DESIGN AND ACCESS STATEMENT ADDENDUM 3

STUDIO EGRET WEST ON BEHALF OF ACCESS SELF STORAGE
STURT'S YARD, 48 EAGLE WHARF ROAD, HACKNEY, PLANNING APPLICATION

1.0 ~ DESIGN EVOLUTION:
RESPONSE TO LONDON
BOROUGH OF HACKNEY FEEDBACK
JUNE 2021

Level 03 (typical upper) floor plan

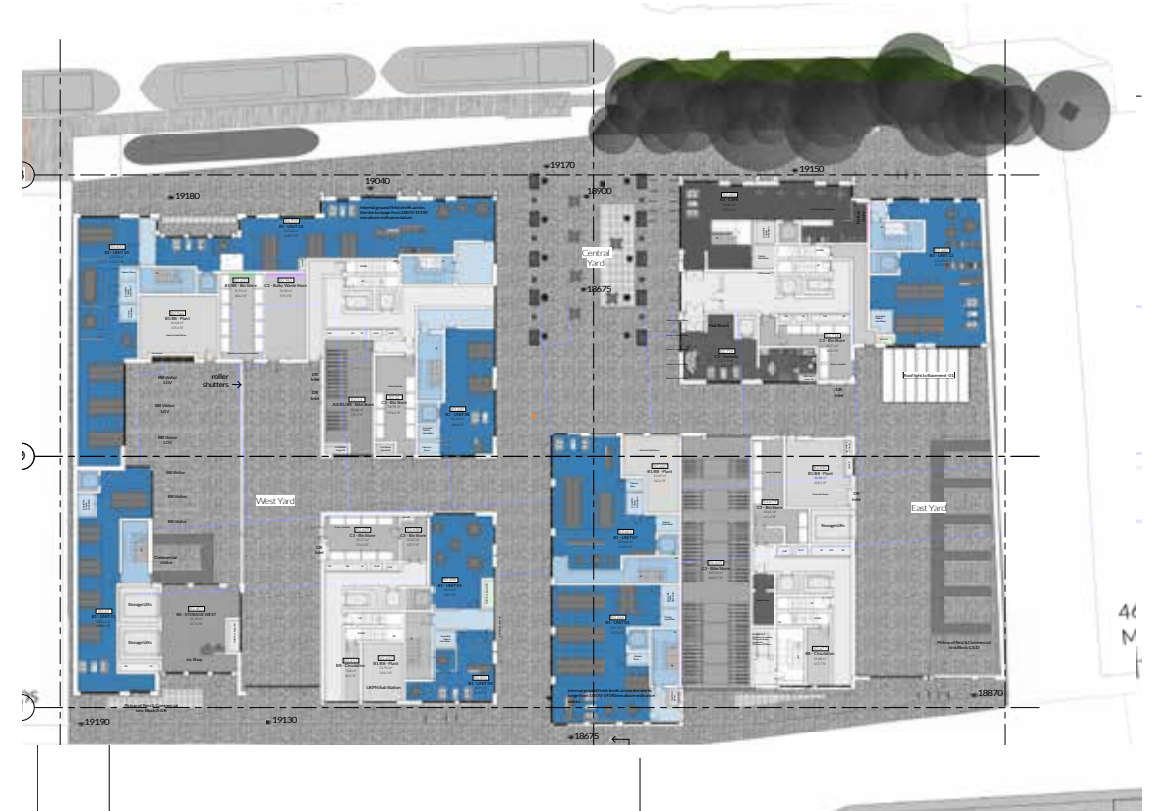
LBH DESIGN COMMENTS (24/06/21) :

Repositioning/ privacy screening/ part recessing of the balconies within the internal faces of the blocks, so that they do not directly neighbour other balconies/ windows.

Ideally balconies should be placed off living rooms and staggered to reduce the loss of daylight to those rooms. Alterations to the unit layouts to enable such changes would be welcomed.

Revised figures for the internal daylighting/ sunlight of rooms should be provided.

Balcony positions within courtyards have been explored by SEW and EB7. The exercise concluded that the balconies could be staggered further apart without impacting further on the daylight/sunlight levels into units with balconies and windows. In addition to the repositioning of balconies an integrated 1800mm high frosted glazing panels have been added to the side of balconies in four locations which are in close proximity to neighbouring windows.

Recessed balconies within the courtyard have been investigated by SEW previously. Inset balconies were seen to be detrimental given their impact on the quality of layout design, daylight/sunlight within internal living spaces and their impression on the form and composition of central blocks. Inset balconies have been included on the south facing home within the courtyard of the western block where internal daylight/sunlight levels are sufficient.

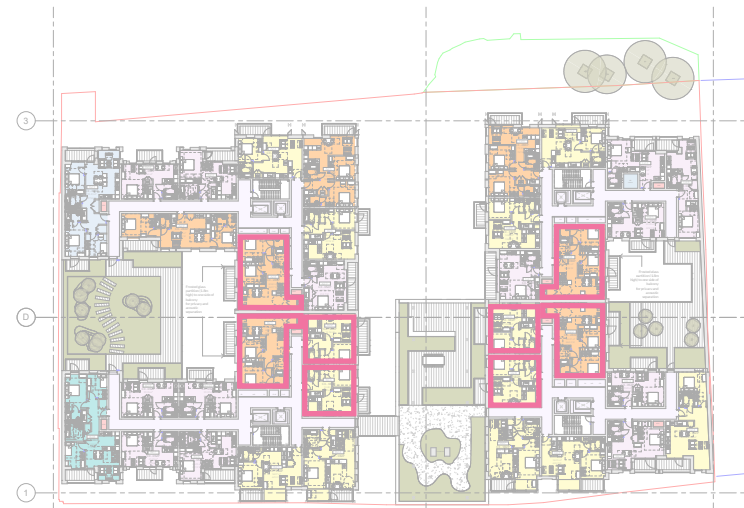
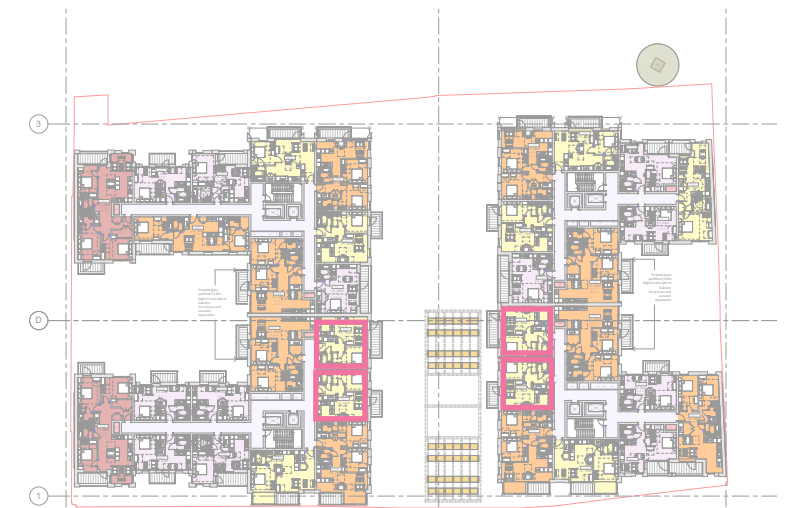
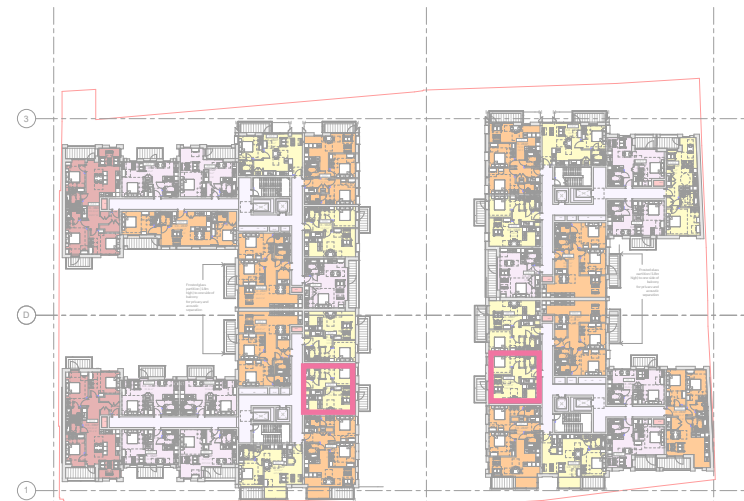
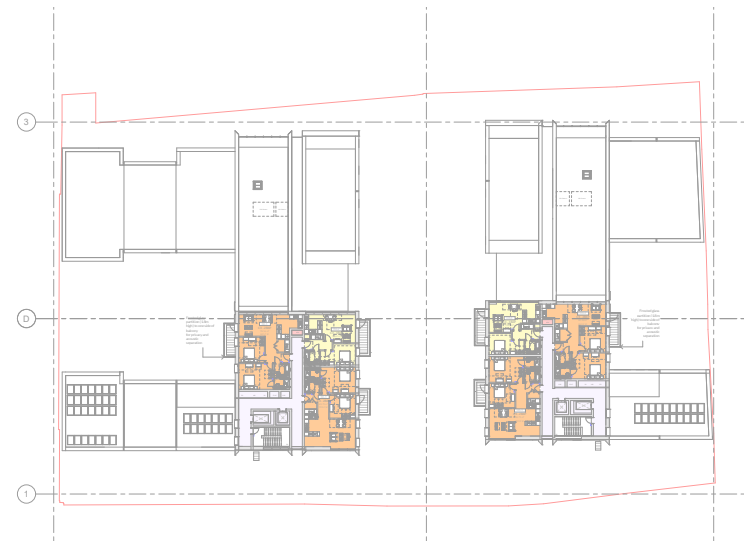
LBH DESIGN COMMENTS (07/07/21) :

Clarification of affordable housing location required.

The location of affordable homes is highlighted on the adjacent plans.

Affordable Homes Provision:

14 units split between:
 10 x 1 Beds (Hackney Living Rent)
 4 x 2 Beds (Hackney Living Rent)

Internal courtyard balconies: Frosted glass partition assembly

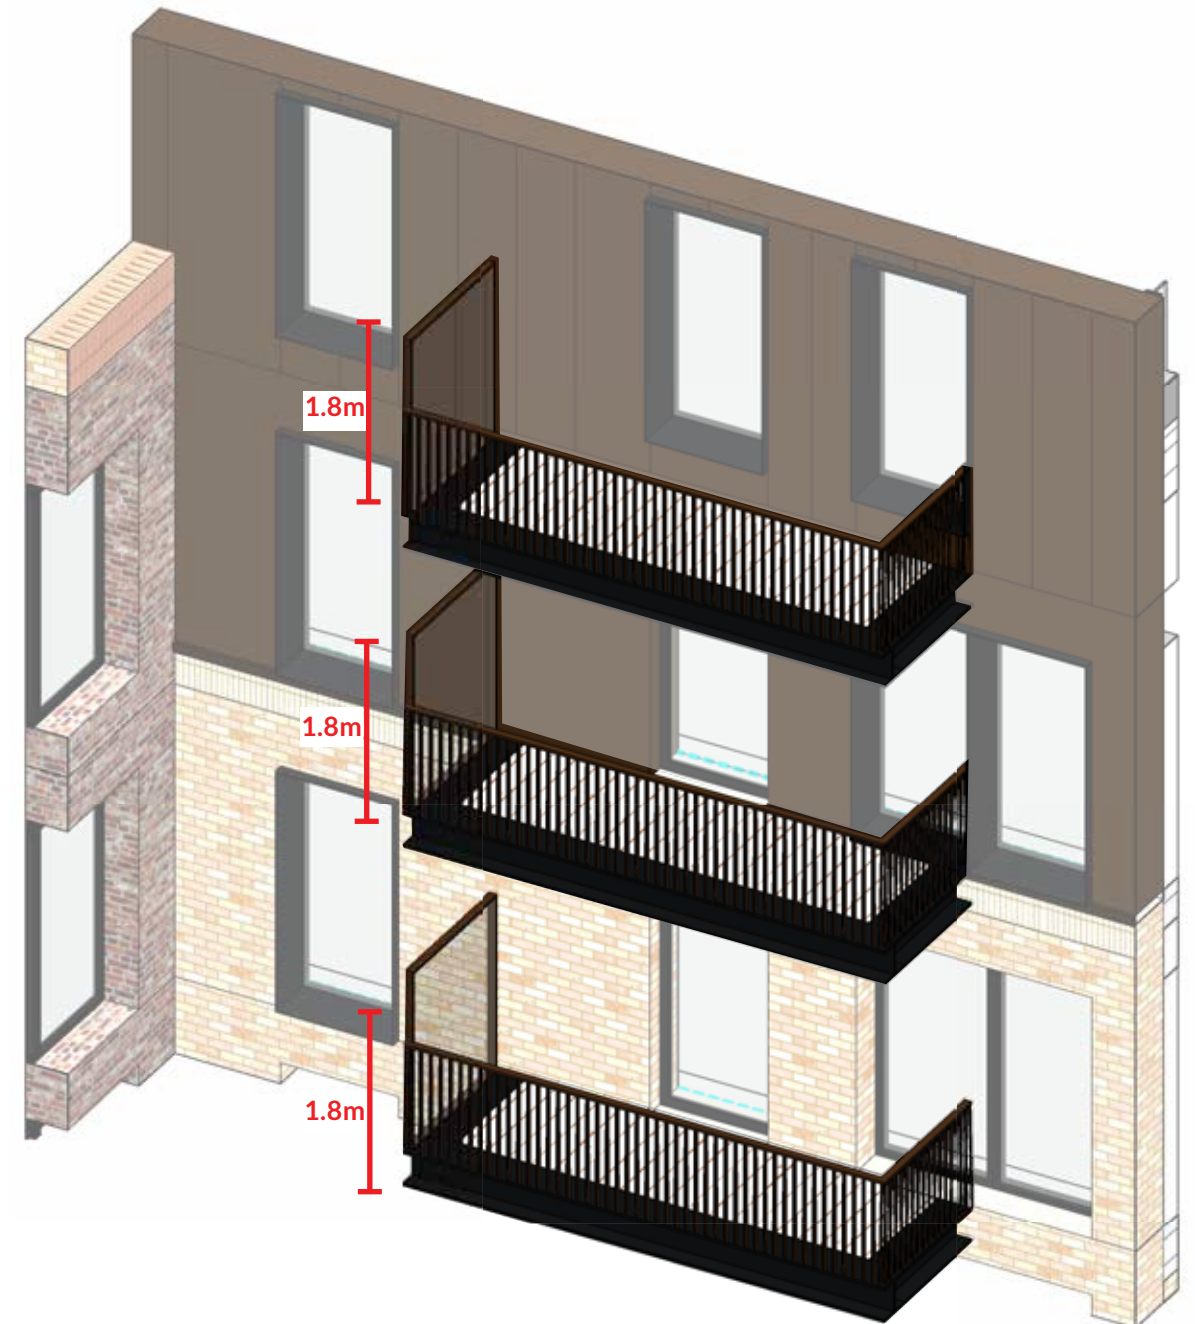
LBH DESIGN COMMENTS (02/07/21) :

Further clarification of position and detailing of internal courtyard screens.

SEW have updated planning drawings to note the location of balconies with frosted glass partitions in GA plans.

The design intent is for the frosted glazed panels is to provide suitable privacy without impinging on daylight to corner windows. Panels will be integrated into the balcony design with aluminium framing to match the colour and proportions of balcony railings and balustrades.

Drawings 0276-SEW-PA-ZZ-DR-A-001308 and 0276-SEW-PA-ZZ-DR-A-001310 have been updated to describe call-out and assembly details for 1.8m high umber aluminium frames and frosted glazed screens as noted on the relevant drawings and material legend.

Level B1 - GA Plan

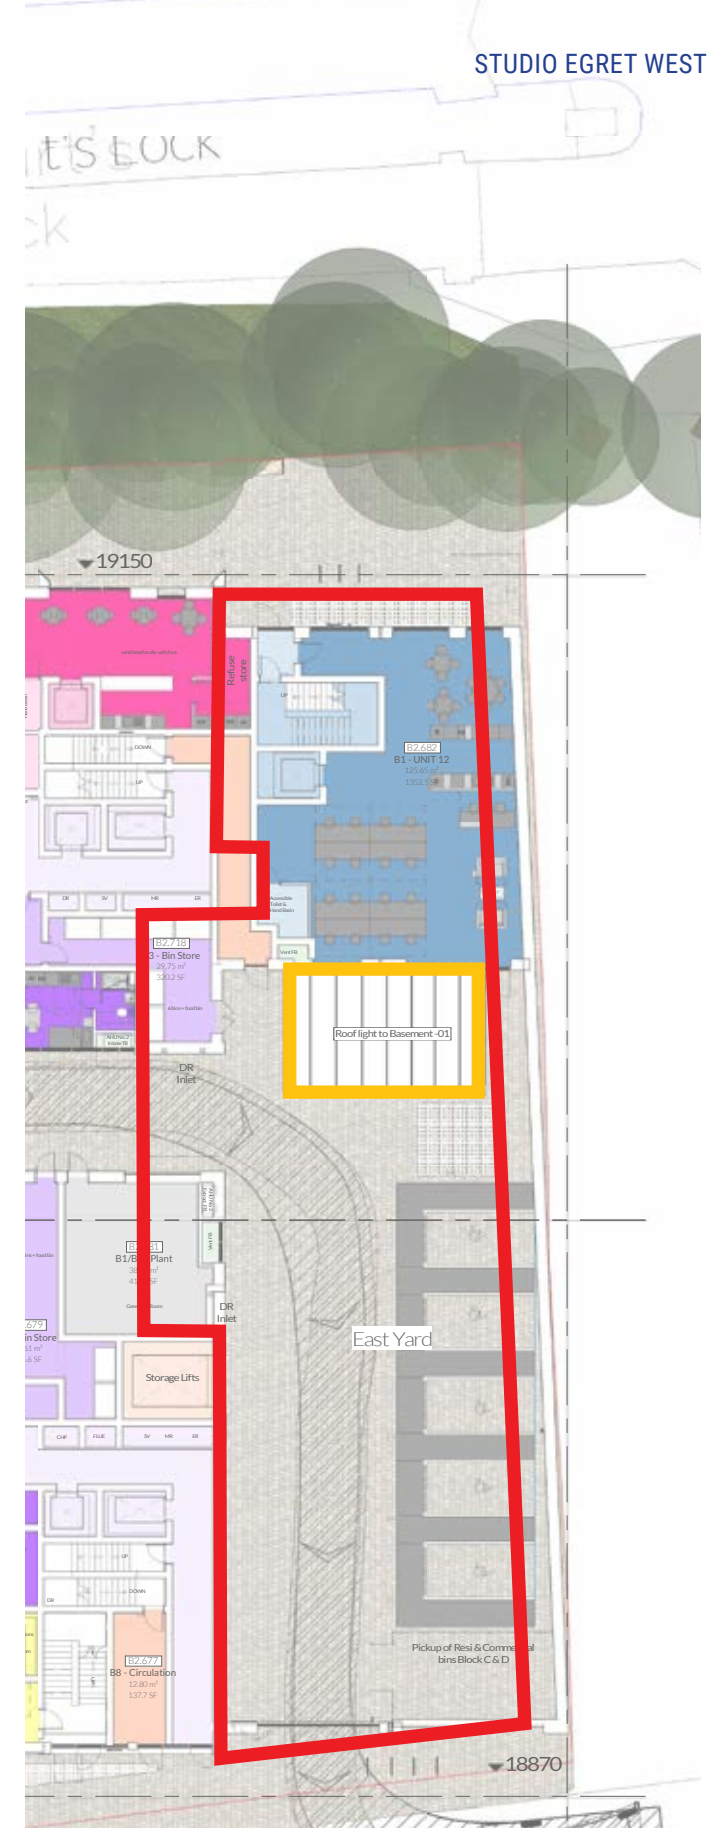
LBH DESIGN COMMENTS (24/06/21) :

Provision of light-wells (rather than a roof light) for the basement office floorspace.

SEW have confirmed that this is not possible owing to the vehicle tracking into courtyard space. Additional glass-bricks can be provided over the space to allow natural light into the space but would be limited. Glass-bricks in this area could be reserved as a condition.

Level 02 social terrace - GA plan

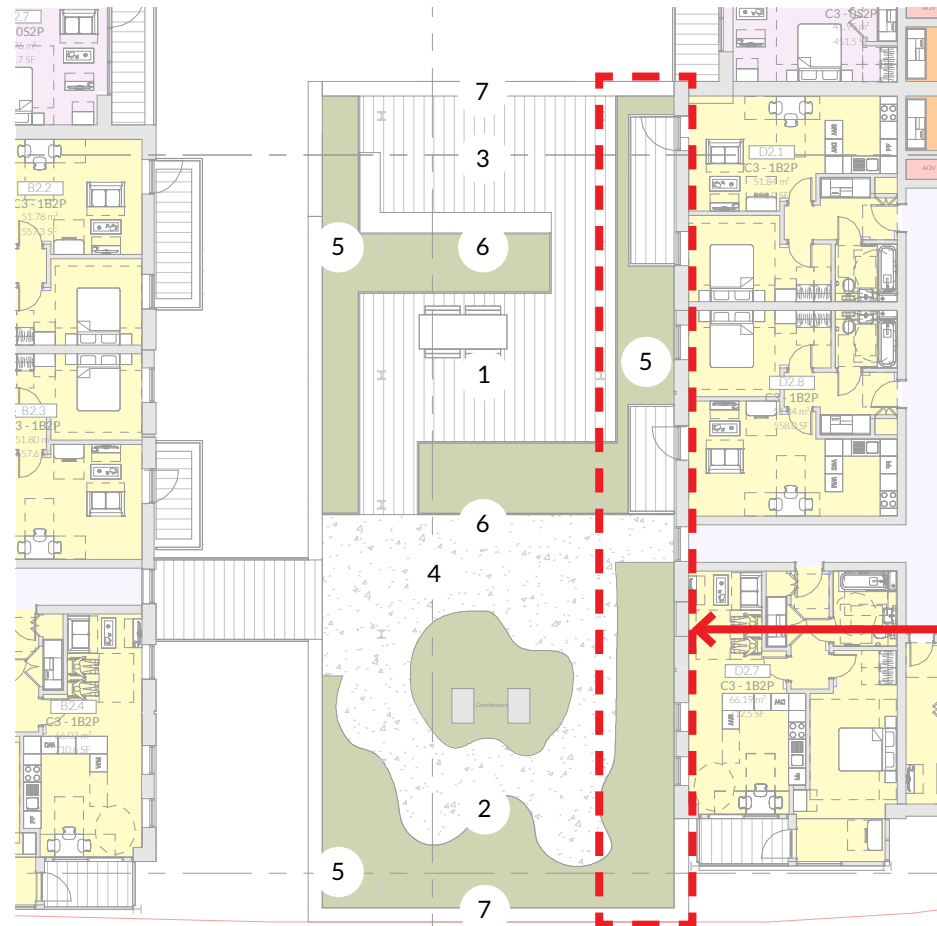
LBH DESIGN COMMENTS (24/06/21) :

Is the provision of defensible space in front of the second floor residential windows overlooking the second floor amenity spaces adequate?

Please also provide details of what this does to the overall provision of communal amenity/play space.

SEW believe that defensible planting is the most appropriate means to provide privacy to homes which are adjacent to communal terraces whilst simultaneously creating an attractive verdant space for people to sit, relax and eat. This approach will ensure that both private and shared terraces feel embedded in planting. The character and use of different outdoor areas will be defined by different planting types with varying densities. Defensible boundary planting is a common strategy used to help alleviate overlooking and noise concerns.

In the majority of cases, private outdoor amenity spaces in front of apartment windows maintain a minimum width of 2m to provide privacy and separation for residents living adjacent to shared outdoor amenity terraces. On the eastern edge of the social terrace planted boundaries have been increased in width to ensure 2m is retained in all instances. A mixture of structural and herbaceous plant species have been specified within the planting palate to ensure that robust species can be used adjacent to windows. In the central social terrace a raised truss frame is populated with climbing plants which will provide an additional level of screening between flat windows and amenity spaces.

Width of defensible planting increased from 1.5m to 2m

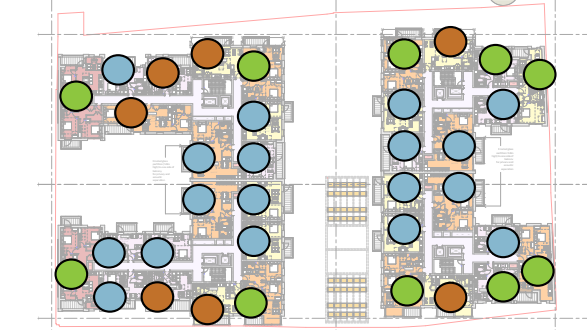
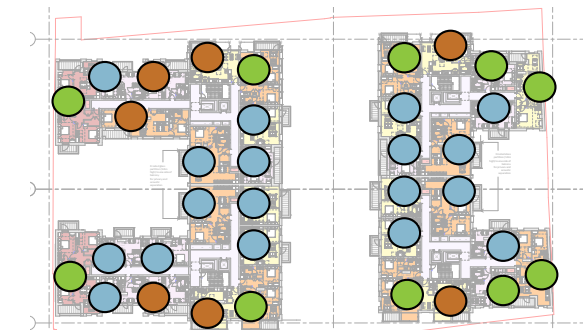
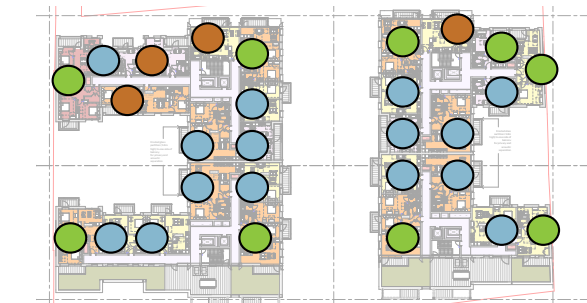
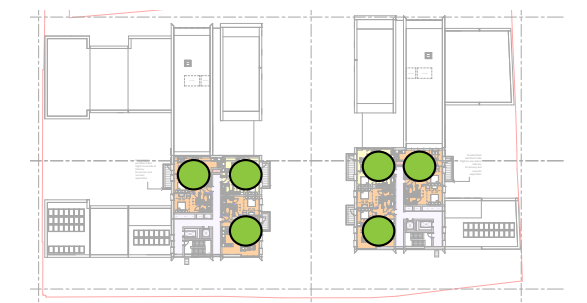
LBH DESIGN COMMENTS (24/06/21) :

Officers have asked for the number/proportion of single aspect units, along with their orientation.

There are 69 (50%) single aspect homes in the scheme of which 16 (12%) are single aspect north facing. Details of single, corner and dual aspect homes are shown in the adjacent table and diagrams.

Please note that corner aspect homes are considered to be dual aspect.
